REMARKS

This Amendment is submitted in response to the Office Action dated March 4, 2004, having a shortened statutory period set to expire June 4, 2004. In the present Amendment, Claims 2 and 9-11 have been cancelled, and Claims 12-17 have been added. Claims 1, 3-8, and 12-17 are now pending.

FIG. 3

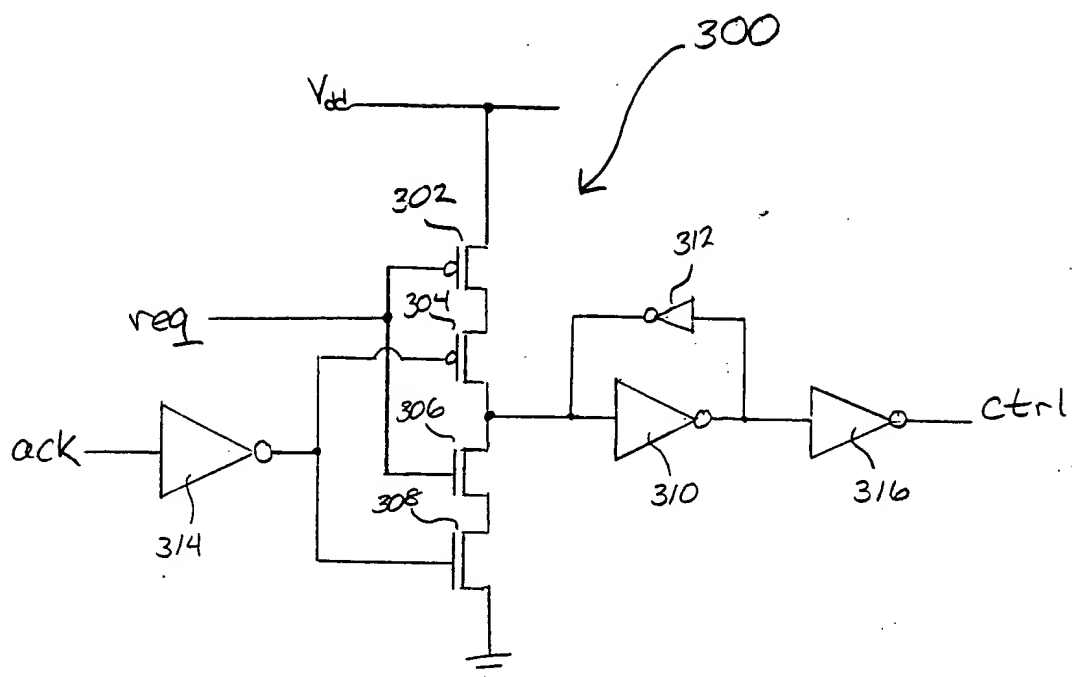
Responsive to the Examiner's correct observation, Figure 3 has been amended as indicated on the attached amended figure sheet to include the legend "Prior Art."

-- Prior Art --
